Technical Service Information Bulletin

2.0 Superstructure Support Drain Hole

Bulletin Name: FDM-TSIB-020

Model: Oshkosh S-Series

Figure 2 Right-Hand Super Structure Support

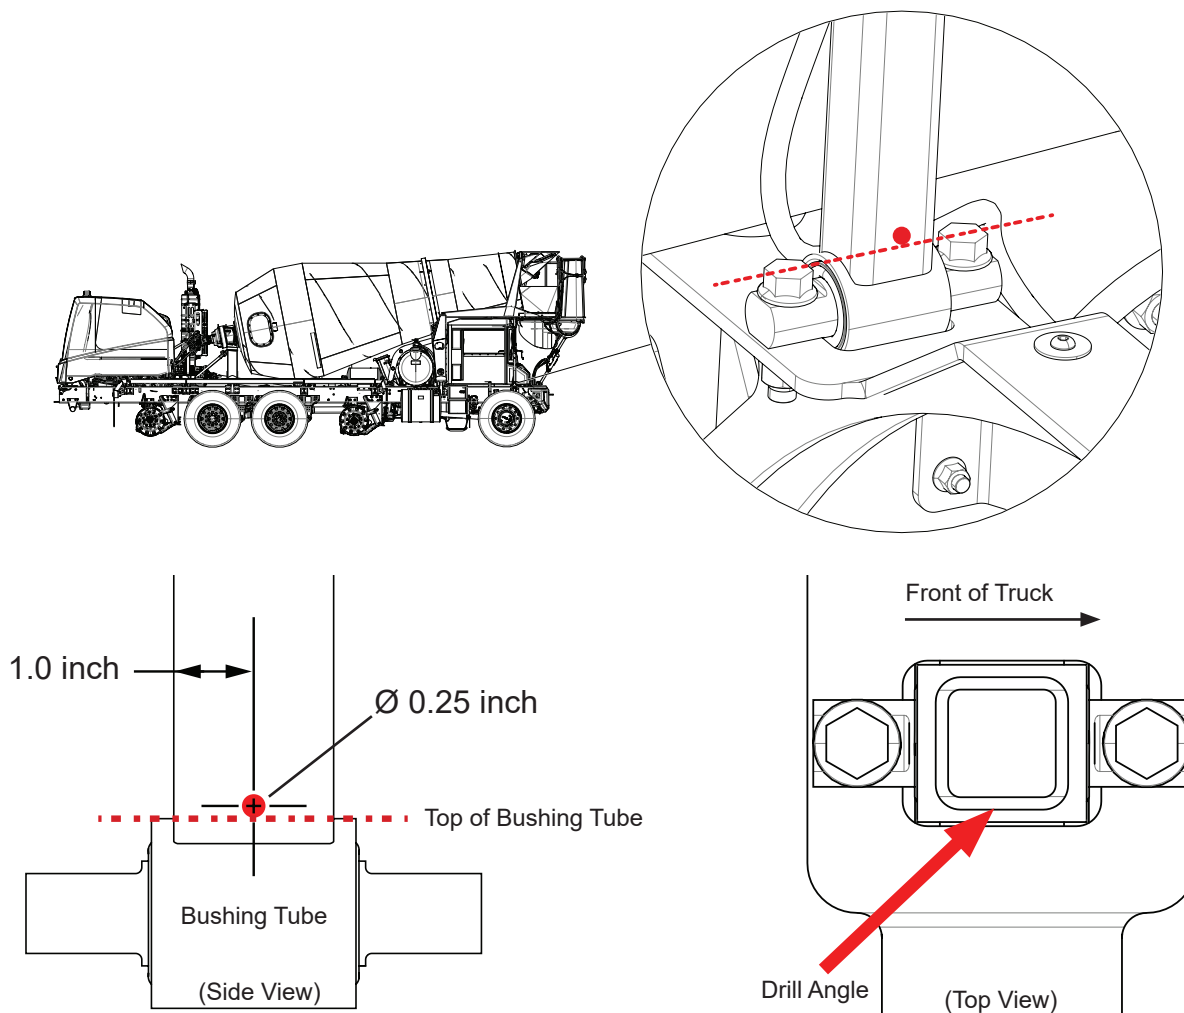
4. Measure and mark the drain hole location on the right-hand superstructure support, see Figure 2.
5. Punch the drain hole location in the superstructure support using hammer and metal punch.

6. Drill drain hole parallel with the ground and angled toward the rear of the truck. See Figure 2.

Figure 4 Left-Hand Super Structure Support

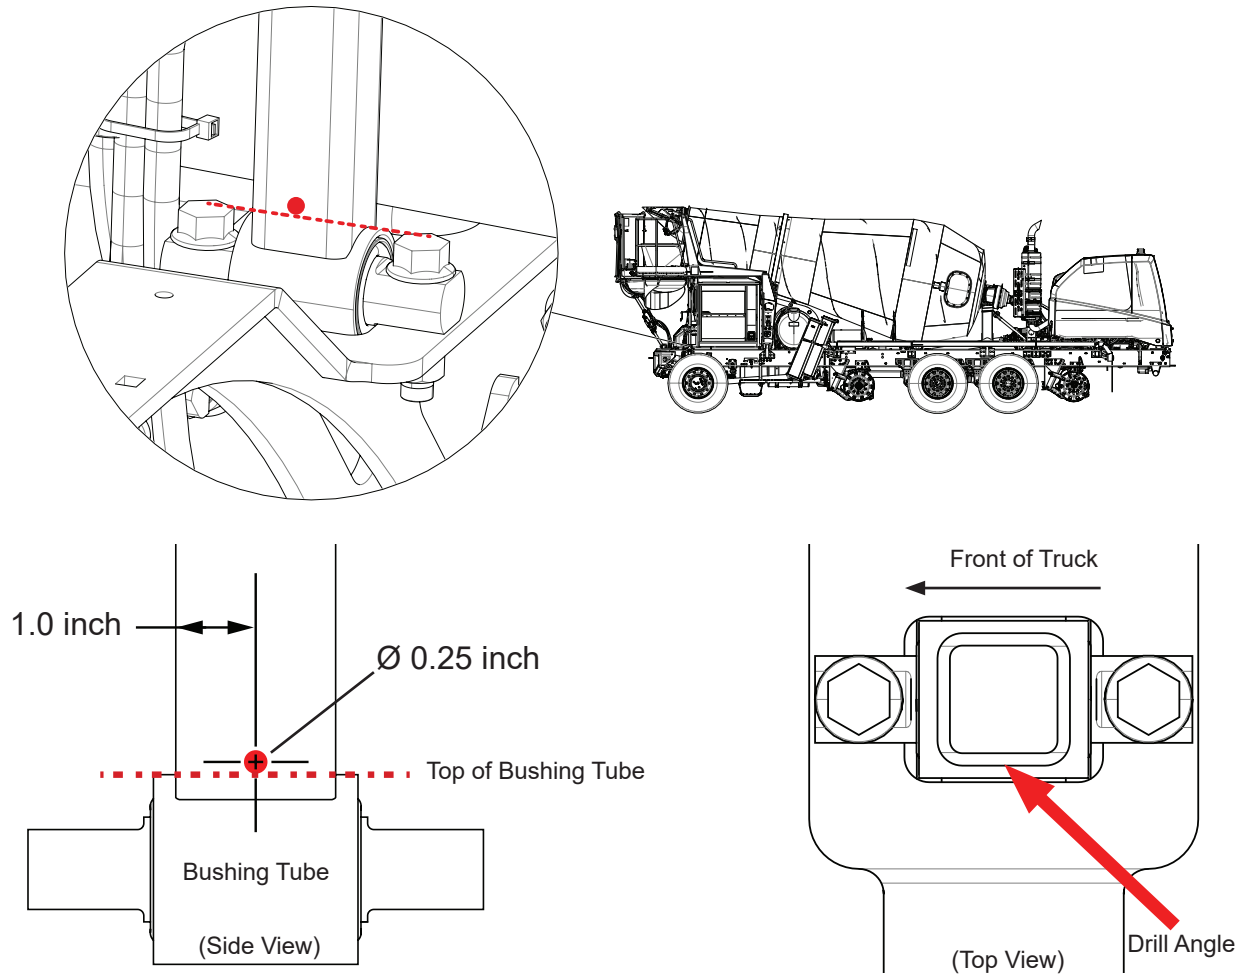
9. Measure and mark the drain hole location on the left-hand superstructure support, see Figure 4.
10. Punch the drain hole location in the superstructure support using hammer and metal punch.

11. Drill drain hole parallel with the ground and angled toward the rear of the truck. See Figure 4.
